Amendments to the Drawings:

Attachment: Replacement Sheets "3/4" and "4/4".

**FIG. 6**

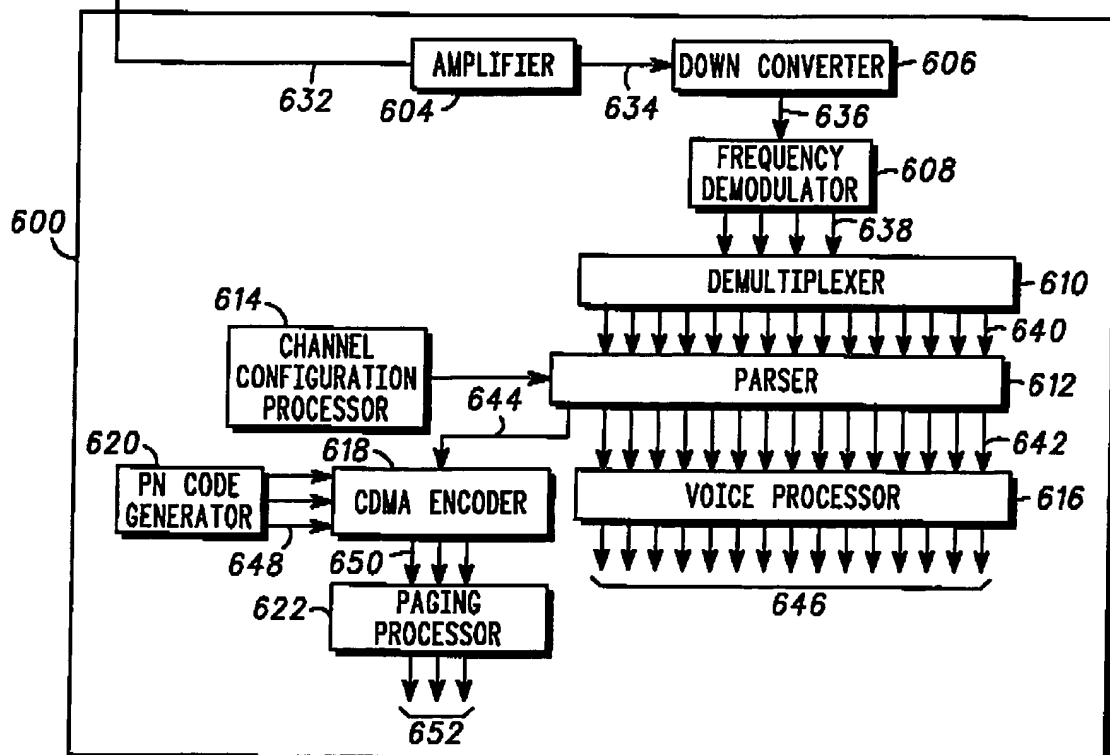
The attached sheets of drawings include changes to FIGS. 6 and 7 as required by the Examiner. More specifically, Applicant has amended FIG. 6 to clarify that element 608 is a "frequency demodulator", and has amended FIG. 7 to clarify that step 704 now recites "frequency demodulate data". These sheets, which include FIGS. 5-7, replace the original sheets including FIGS. 5-7.
